# SPARE PARTS LIST

CHAIN SAWS

365SP from 2019-10-

# Illustrated Parts List - IPL Update

503 63 76-03/04

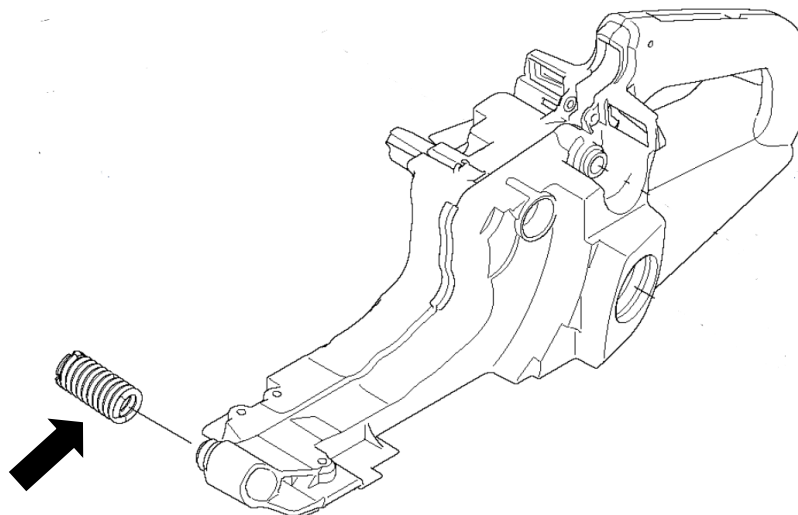
New Antivibration element with ground top on the metal spring. The plastic plug is changed. This gives longer thread length and therefor better fastening of spring in plastic plug.

Reason: Improved durability of antivibration element.

New articles Antivibration element 503 63 76-03 and 503 63 76-04(hard)

Page Title	Ref.No	New part no	Name	Excl. part no.	Remark
FUEL TANK	17	503 63 76-03	ANTIVIBRATON ELEMENT	503 63 76-01	New spare part, std
	17	503 63 76-04	ANTIVIBRATON ELEMENT	503 63 76-02	New spare part, Hard
